METROPOLITAN GOVERNMENT OF NASHVILLE AND DAVIDSON COUNTY

STAFF RECOMMENDATION
2517 (2619-A) Ashwood Avenue
September 17, 2014

Application: New construction – infill and outbuilding
District: Hillsboro-West End Neighborhood Conservation Zoning Overlay
Council District: 18
Map and Parcel Number: 10415049600
Applicant: Robert Thompson, Pfeffer Torode Architecture
Project Lead: Sean Alexander, sean.alexander@nashville.gov

1 SITE PLAN
 SCALE 1/16" = 1'-0"

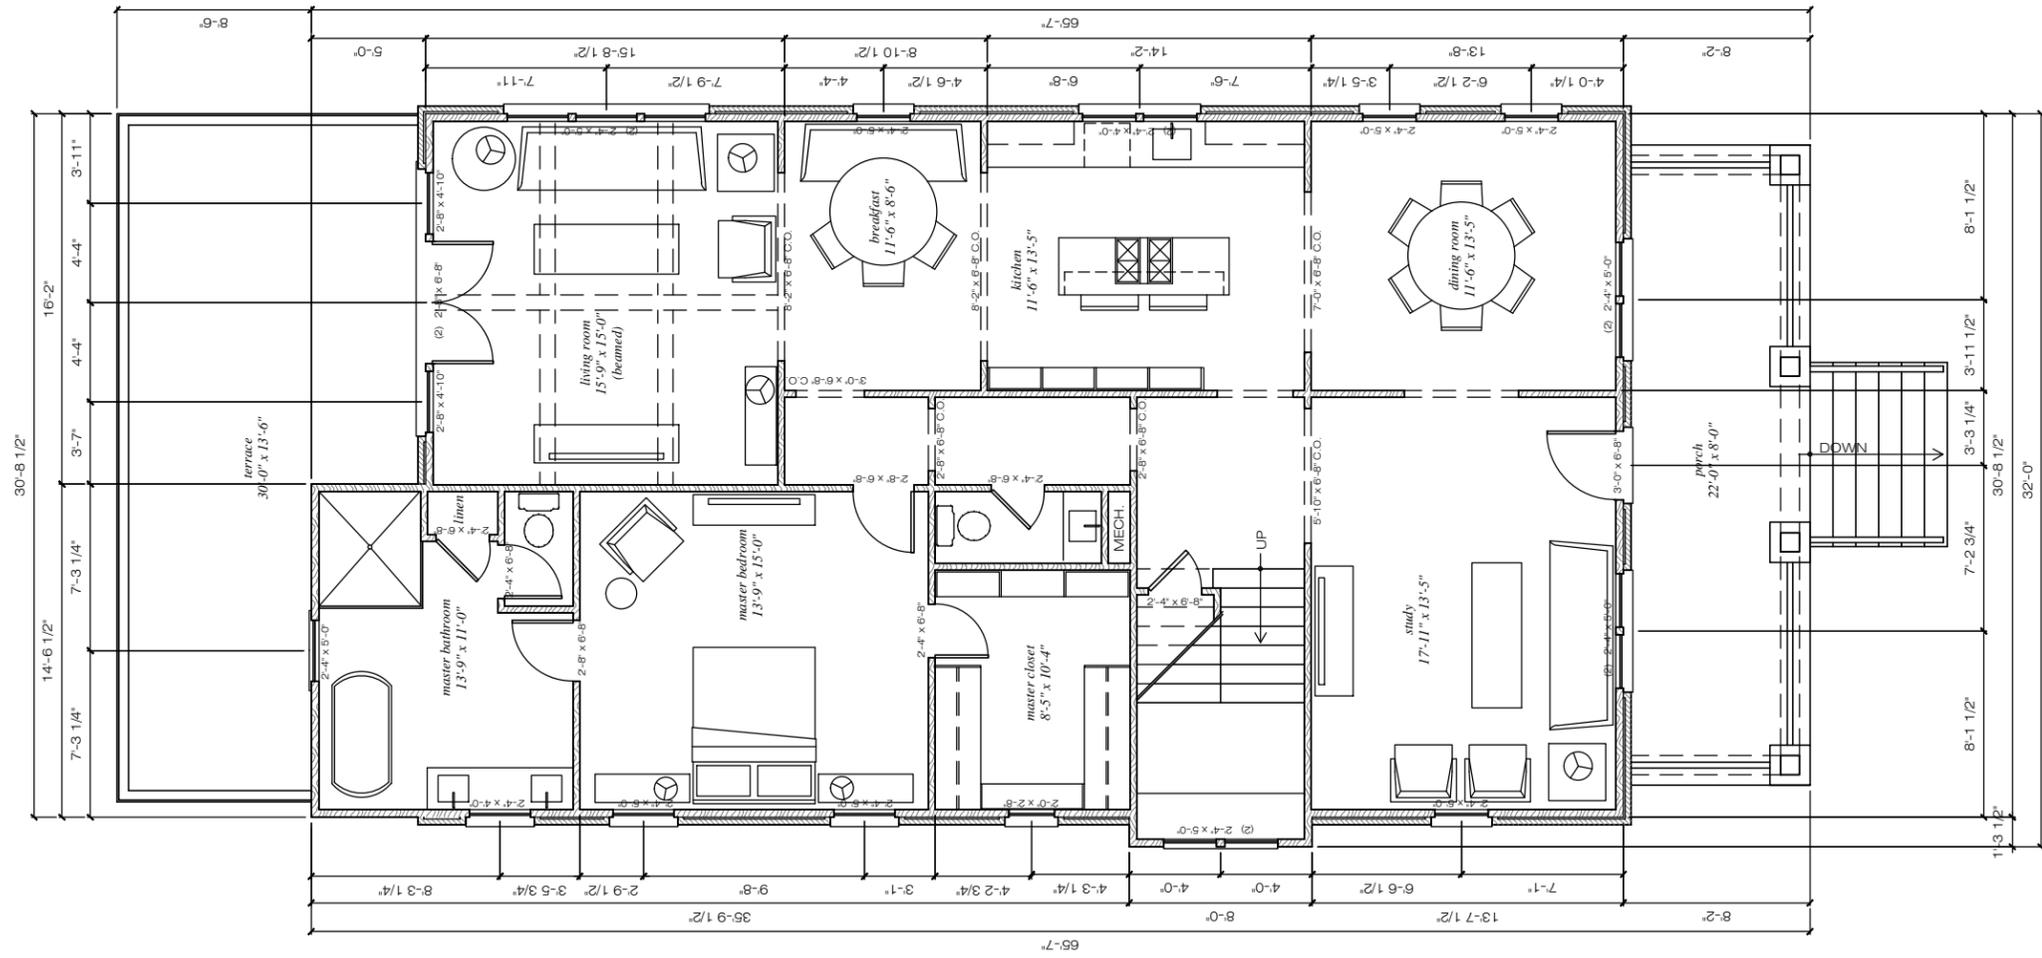
The new house will be situated in the lot with the front edge aligned with the front of the adjacent historic house to the right. The building will be five feet (5') off of the left side property line, and thirteen feet (13') from the right. There will be twenty-two feet (22')

between the new house and the one to the right, with each house having a driveway in the space between them. The majority of houses in the surrounding area have driveways, with several paired like that in the current proposal. These setbacks are compatible with the surrounding context, and meets section II.B.1.c of the design guidelines.

The new house will match the orientation of the surrounding context. However the plans do not indicate that there will be a walkway connecting the front porch to the street, a condition always found on surrounding historic houses. Staff finds the project meets design guideline II.B.1.f.

- The front dormer shall sit at least two feet (2') back from the front wall of the house, and
- There shall be a walkway connecting the front porch to the street, and
- Staff shall approve the color and texture of the brick, and
- Staff shall approve the selection of windows and doors are approved.

ELEVATIONS

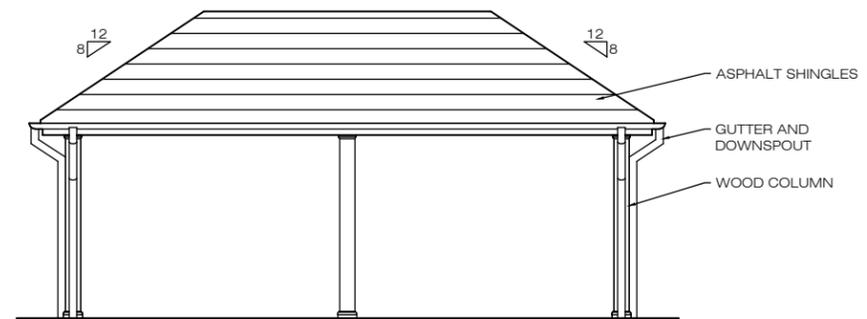
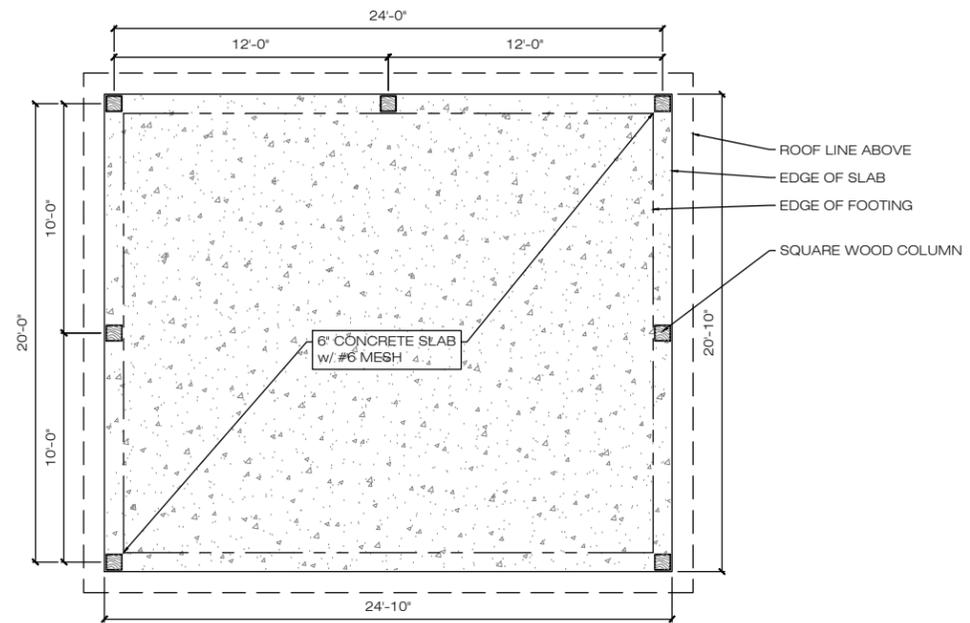
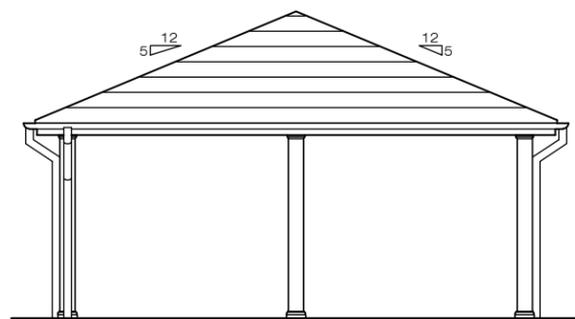
The roof will be hipped with an 8:12 pitch, with a hipped front dormer with a matching pitch. As proposed, the dormer wall stacks directly above the primary front wall of the house, whereas a typical dormer historically would have set back at least two feet (2’). The front porch will have a hipped roof with a pitch of 4:12. These roofs match the roofs of the adjacent house to the right, and are compatible with other historic houses in the surrounding area. With a condition that the front dormer sit back at least two feet from the primary front wall, staff finds that the project meets design guideline II.B.1.e.

The location of the HVAC and other utilities was not noted on the plans. Staff asks that the HVAC be located on the rear façade, or on a side façade beyond the midpoint of the house. The project meets section II.B.1.i.
